Technical Note

Our Ref	22015-TN-4-R0
Date	30 May 2025
Author	Andrew Jameson
Client	Domis Construction
Issued To	Domis, Deloitte

Waterhouse Gardens, Manchester Block C & D – Response to EHO Comments on PC18 & 19

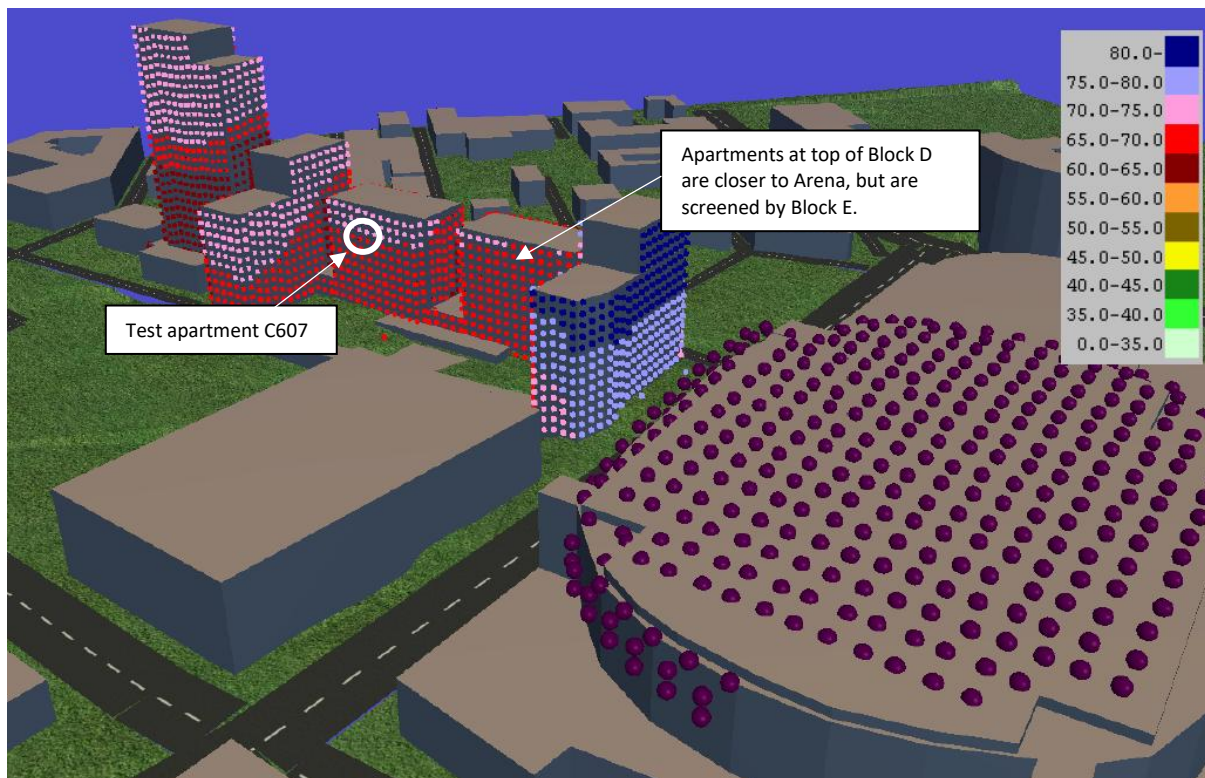
- 3. We can accept the assessment provided but only 4 units have been tested so far and we will require at least 10% of residential apartments to be tested for validation purposes. We will also require further comment with regard to the assessment during an event at the Arena as we will also need validation assessment of any apartments that over look the roof of the Arena. It is not clear if the apartments tested were of sufficient height or location to over look the Arena roof.***

Referring back to the continuous noise logging (environmental and event noise) survey for Block C & D, measurements to the rear (south facing) apartments were undertaken at Level 6 in apartment C607 (Block C) which was the highest available apartment for testing and overlooked the roof of the Arena roof. It represents the most exposed area of the rear elevation of both Blocks C & D to noise breakout from the Arena roof. Note, upper level apartments in Block D benefit from screening afforded by Block E, whereas these apartments in the top corner of Block C do not. See below image from the noise map to help clarify the position.

Based on the noise model above, you will also notice the eastern face of Block B (upper floors) is exposed to Arena noise breakout. Incident music levels are likely to be equivalent to those on the upper floors of Block C & D. Again, we will increase the concentration of noise logging to capture apartments in this area.
